Determination of a Site Plan Correction Request

Project Name: Harbison Auto Sales SP-03-0469C

Re: Request for Site Plan Correction to Harbison Auto Sales
Case #: SP-03-0469C (Cor #: 4)

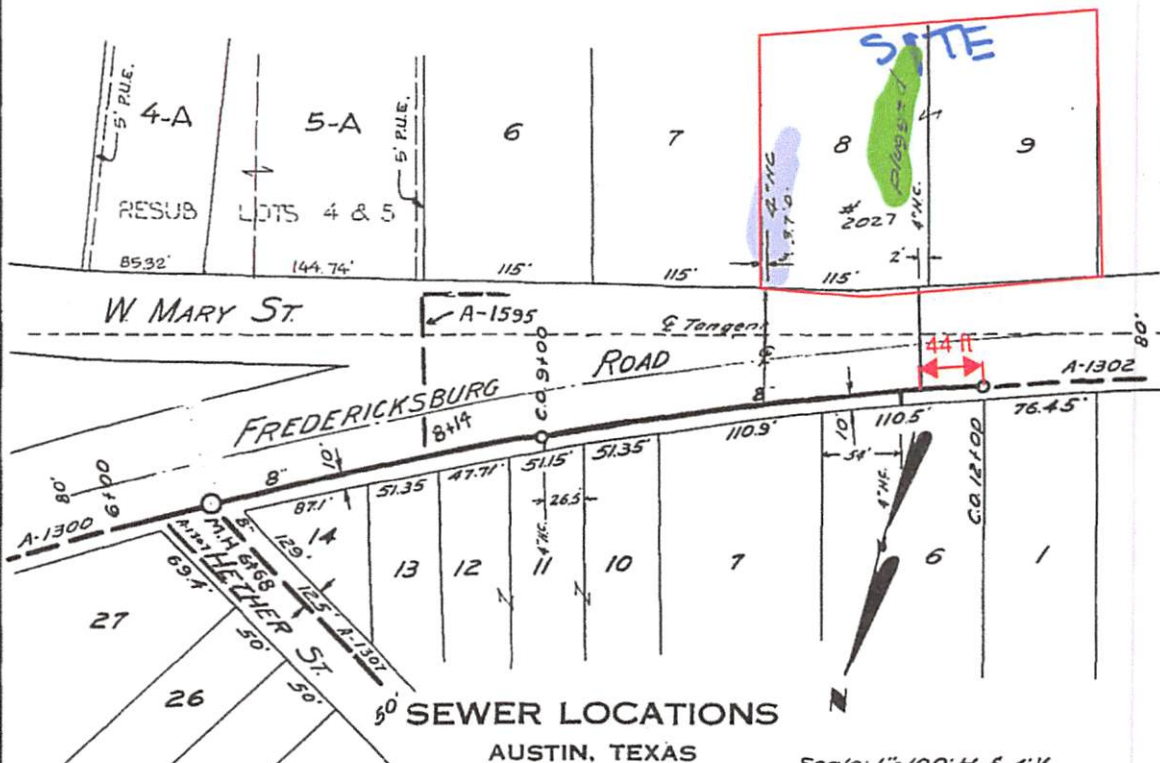
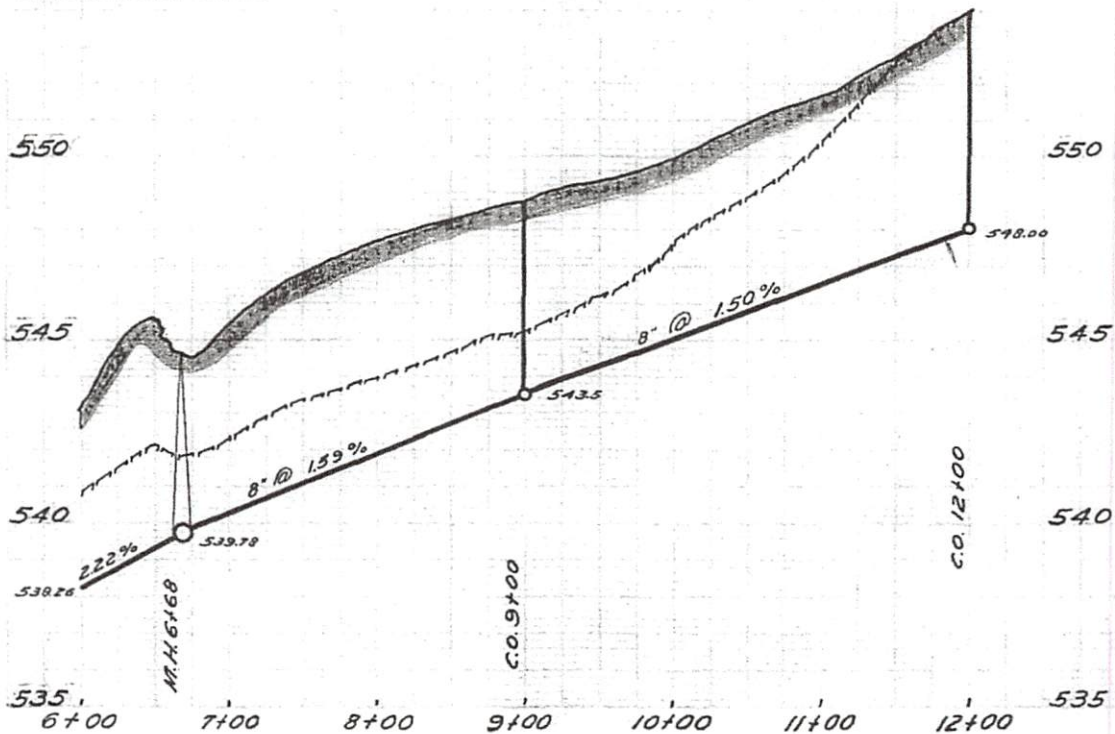
AFD; Engineer performing change must seal change if they are not the engineer of record. Provide an occupant load calculation that clearly shows how it was determined/calculated. Clarify – Does the Deck have its own exiting on so occupants on the deck have to exit back through the building including mobility impaired occupants? What is the 2,637 sq ft 1 story bldg. going to be used for?

Response: Occupant load attached. Deck will have separate HC accessible exit to the site, not requiring entry to the building. Utility plan changes will be signed/sealed by registered professional engineer – site changes involve re-striping parking and sport courts on existing pavement.
